Service Letter No. 373

SUBJECT: Installation of Oil Shields on Airborne Mechanisms Dry Vacuum Pumps, Models 113A1 and 113A5

MODELS AFFECTED: PA-22-108 Colts - Serial Nos. 22-8000 to 22-9256 inclusive
PA-24 and PA-24 "250" Comanches - Serial Nos. 24-2176 to 24-2987 inclusive
PA-28 Cherokees - Serial Nos. 28-1 to 28-494 inclusive

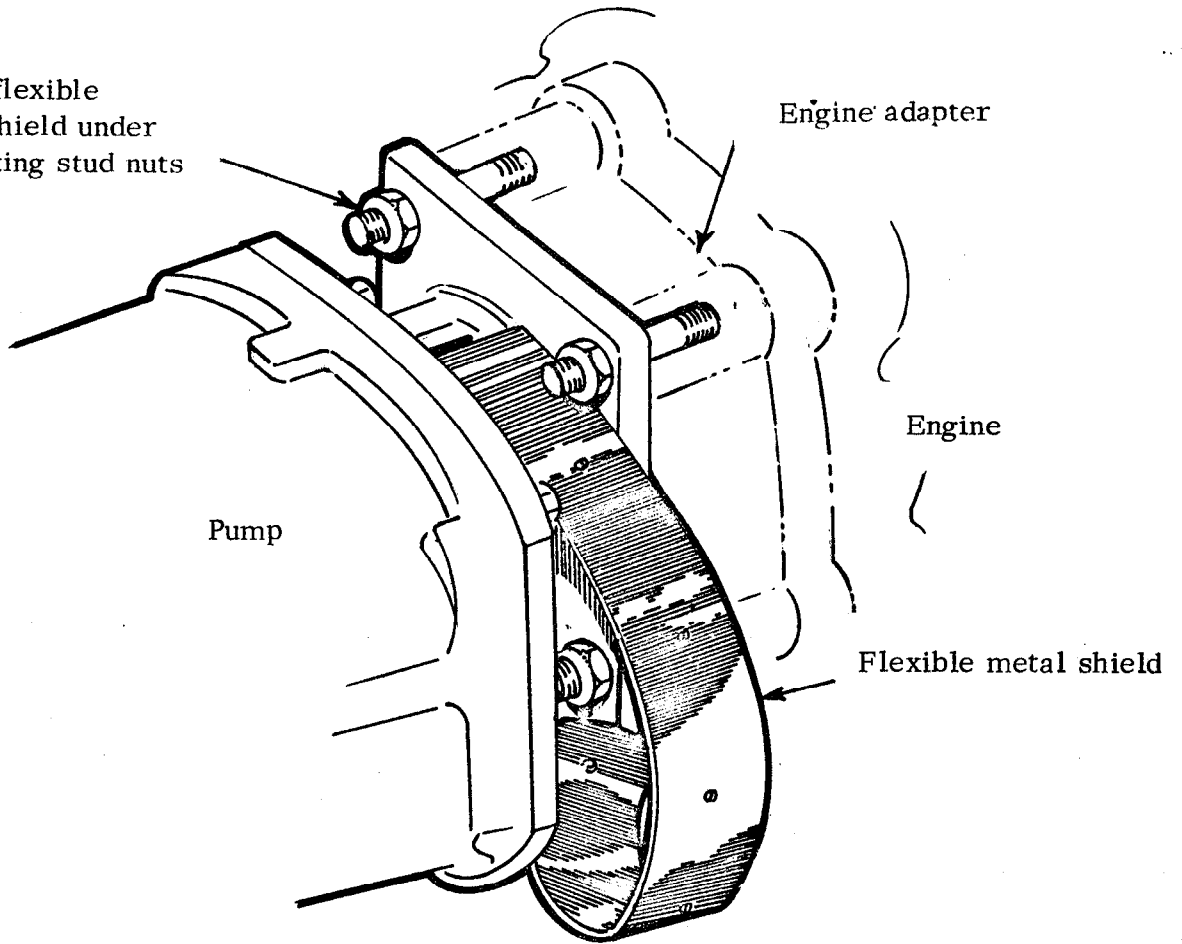
It has been determined that occasionally oil or cleaning solvents have entered the ventholes in the face of the mounting flange of the 113A1 and 113A5 Airborne Mechanisms dry vacuum pump.

A flexible metal shield, part number 756 143, which is easily installed by threading under the pump mounting bolts, has been designed to protect these openings. Removing the pump is not necessary and the shield does not require fastening as the spring tension of the shield will hold it in its proper position, once installed. Installation of this shield is recommended on the subject aircraft equipped with Airborne Mechanisms Dry Vacuum Pumps. See sketch on the reverse side of this letter.

Install flexible
metal shield under
4 mounting stud nuts

Vent holes to be
covered by flexible
metal shield

During installation or removal of the pump, the shield should be removed to prevent damage to the shield.
